REQUEST FOR INFORMATION (RFI)

PROJECT :	BKK2	R.F.I. NO. :	523213-01-RFI-EL-0008
TO :	CTA	ATTENTION :	CTA
SUBMITTED DATE:	20-Jan-26	NEED REPLY BY DATE :	27-Jan-26

SUBJECT : Request for Confirmation - Confirm the Amount of Monitor and Control Modula - Fire Alarm System

Refer. Drawing : 523213-02-DRG-EL-0170

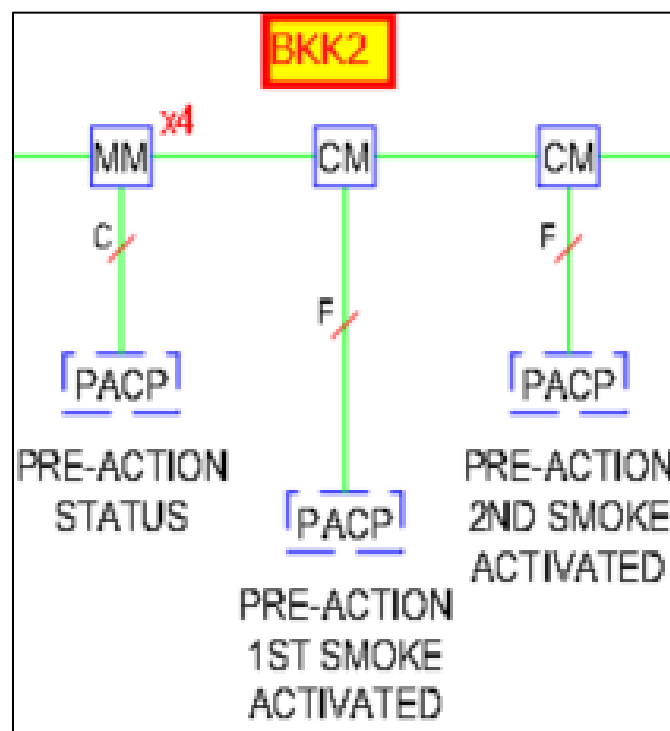
1) According to the fire alarm system schematic design drawing, monitoring modules (FMM) are provided for supervising the status of the PACP (4signal).
However, the reference document BKK01 states a different requirement (4signal) . Please clarify which requirement shall be followed .

Description : As design DWG. Of Fire alarm system Schematic have 4 module for monitoring status of PACP but refer BKK01 required 5 module. Please clarify which requirement shall be followed?

BKK1	05	{	2nd ALARM PACP1/FIRE RM.1 (-)
		{	2nd ALARM PACP1/FIRE RM.1 (+)
	06	{	LP PACP1/FIRE RM.1 (-)
		{	LP PACP1/FIRE RM.1 (+)
	07	{	SOLENOID_V PACP1/FIRE RM.1 (-)
		{	SOLENOID_V PACP1/FIRE RM.1 (+)
	08	{	WATER FLOW PACP1/FIRE RM.1 (-)
		{	WATER FLOW PACP1/FIRE RM.1 (+)
	09	{	TROUBLE PACP1/FIRE RM.1 (-)
		{	TROUBLE PACP1/FIRE RM.1 (+)

AUR :
1. Please kindly verify the requirement for providing modules to monitor the status of the PACP in accordance with the Pre-Action diagram for BKK2. In case the BKK2 Pre-Action diagram does not specify this requirement, please consider applying the same approach and requirements as adopted for BKK1.
